INFORMATION BULLETIN

**Throttle Potentiometer –
Supersedes To Later Version**

MODEL XJS (5.3L)
VIN see text

CD: JLM 20971/CBE
GROUP: AIR AND FUEL DELIVERY SYSTEMS
SUBGROUP: ELECTRICAL FUEL DISTRIBUTION EQUIPMENT
PAGE: THROTTLE POTENTIOMETER - 5.3 LITRE
RELATED PG: 1 OF 2

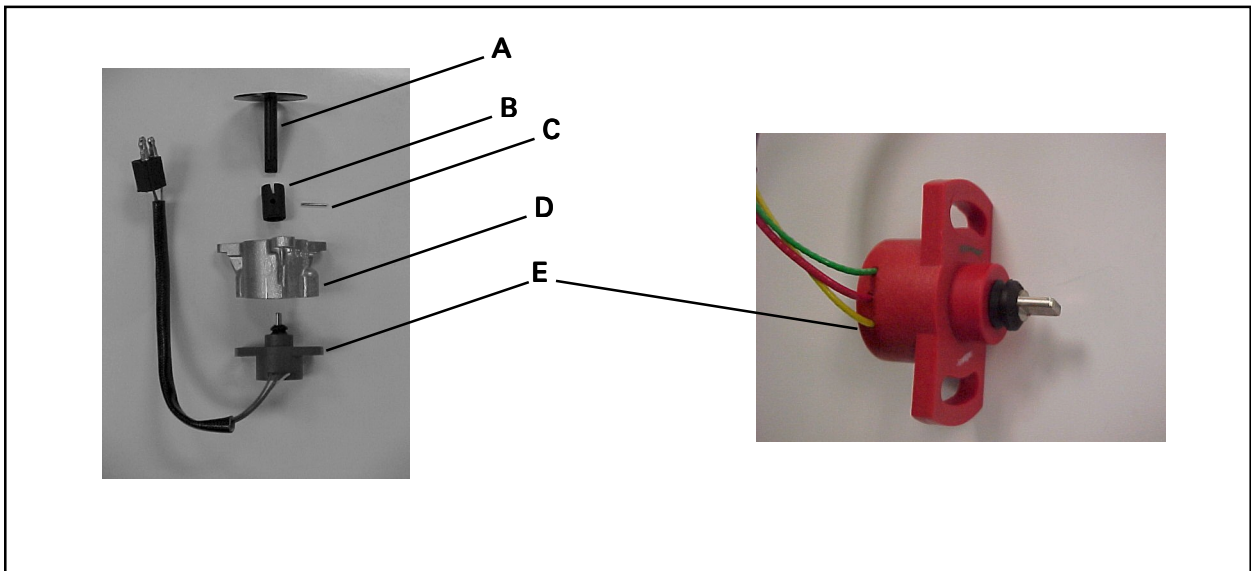
The Bourne (black) throttle potentiometer (EAC 2670) used on engines from engine no. 8S16400-8S61794 is no longer available. Vehicles requiring a new potentiometer should be updated to the later Lucas (red) throttle potentiometer. This modification requires all the parts listed below.

ILL #	PART NUMBER	DESCRIPTION
A	EBC 3566	Spindle
B	EBC 3568	Coupling
C	PA 103161/J	Spring Pin
D	EAC 9567	Adapter Housing
E	EAC 9634	Potentiometer
